KERNODLE LAKE DAM NO. 1

MO 20140

**PHASE 1 INSPECTION REPORT
NATIONAL DAM SAFETY INSPECTION**

KERNODLE LAKE NO. 1 EMBANKMENT CROSS SECTION

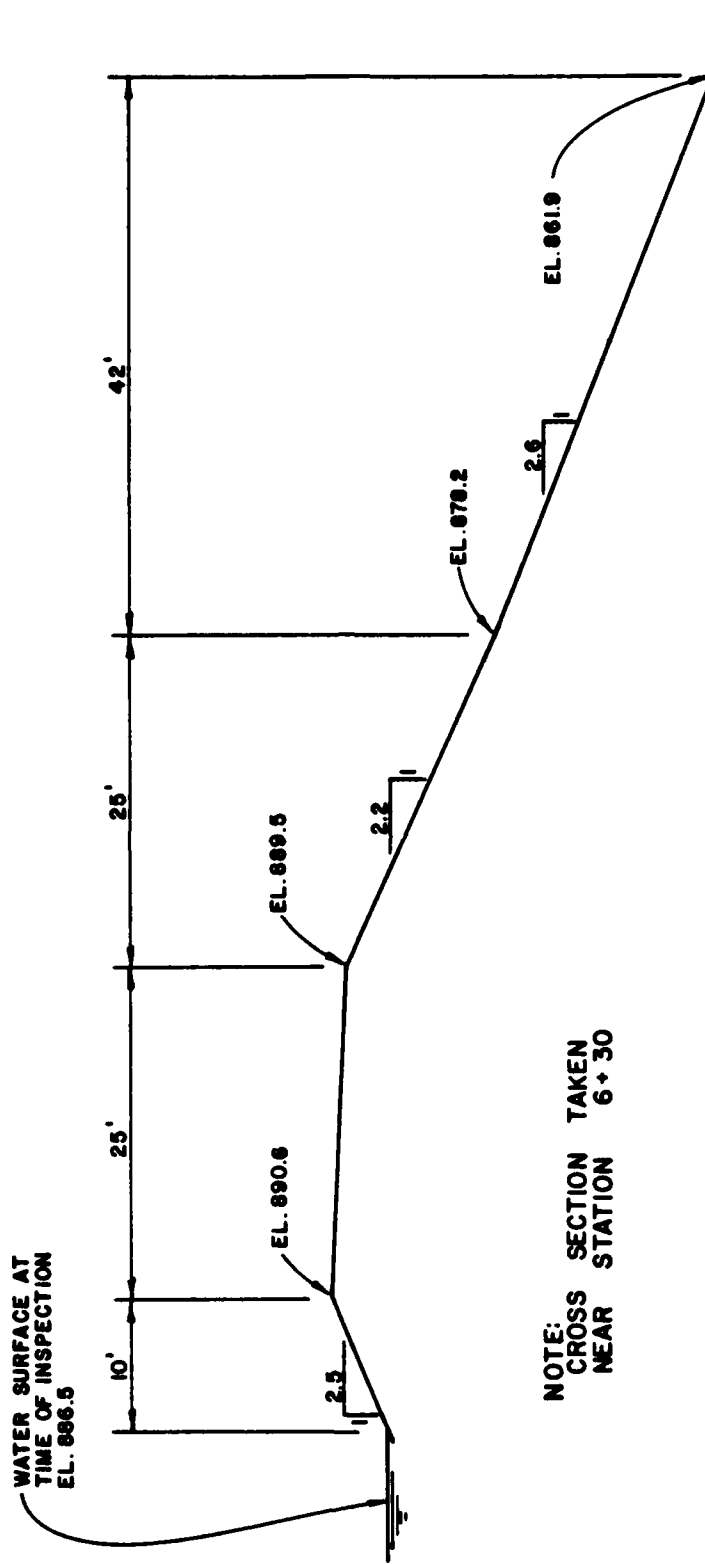
NOTE: CROSS SECTION TAKEN
NEAR STATION 6+30

SECTION DATA OBTAINED
FROM FIELD SURVEY.
